**WRITTEN STATEMENT OF TOM MYERS, PhD  
On Behalf of Turner Ranch Properties, LLP and Hillsboro Pitchfork Ranch, LC**

**Before the Mining and Minerals Division of the  
New Mexico Energy, Minerals & Natural Resources Department  
on the Application of New Mexico Copper Corporation for a  
Permit to Operate the Copper Flat Mine in Sierra County, New Mexico**

## II. COMMENTS ON PERMIT APPLICATION

Figure 18: Waste rock storage pile #3 in the north portion of proposed mine, and stormwater conveyance channel. (Source: Figure 11J-1, Copper Flat Project, Impoundment Design Report, 2015)

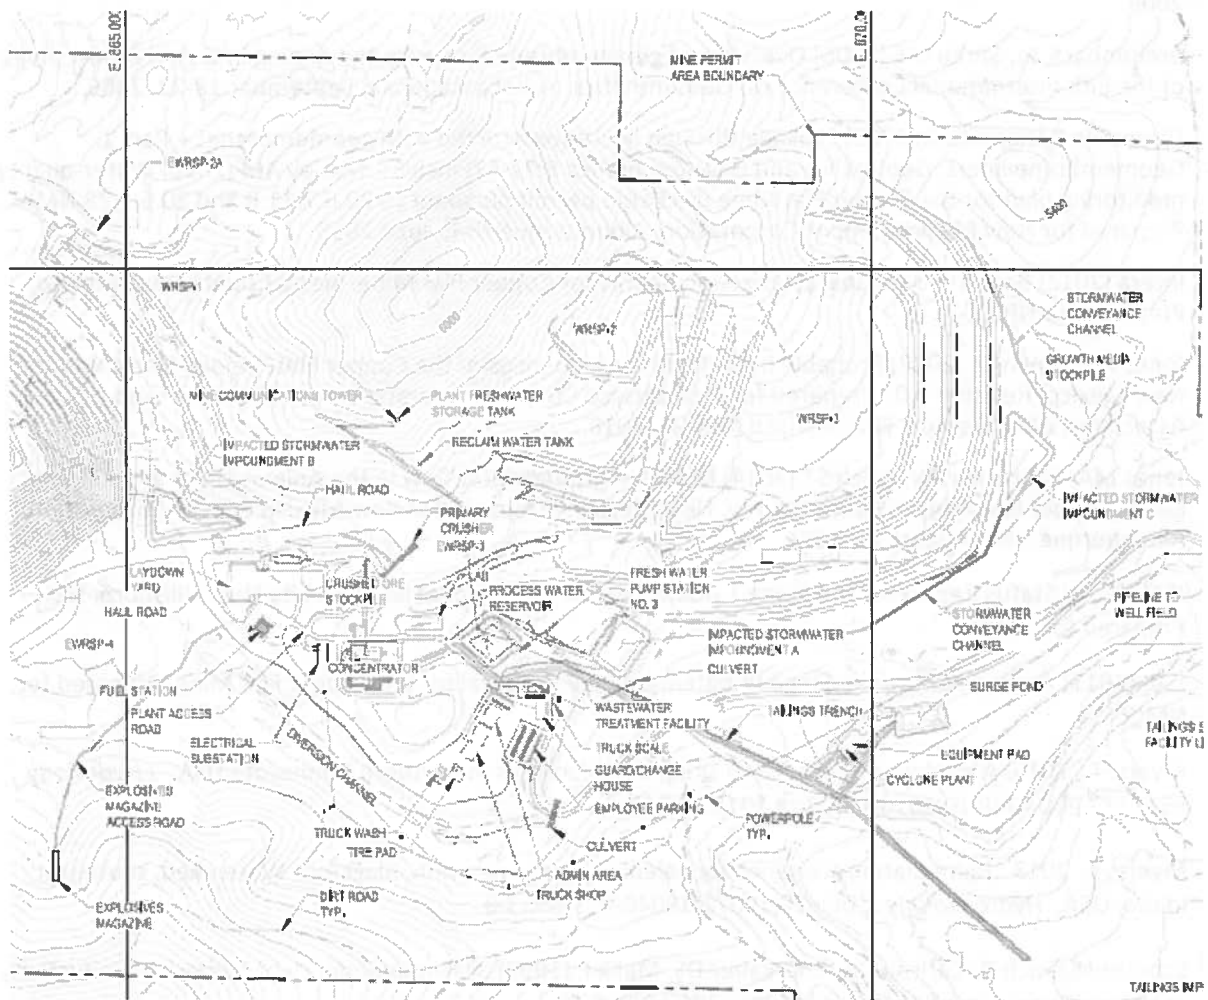
NMCC has also not accounted for potential seepage from unlined stormwater conveyance ditches around Waste Rock Storage Pile #3. The ditch is unlined (Figure 17) and based on scaling from the plan (Figure 18), the ditch is about one mile long. The ditch would capture water running from the waste rock. The water would have contacted waste rock, and therefore could convey contaminants. Because the ditch is unlined, the impacted water could enter the groundwater beneath the waste rock pile, especially wherever the ditch crosses a conductive zone.
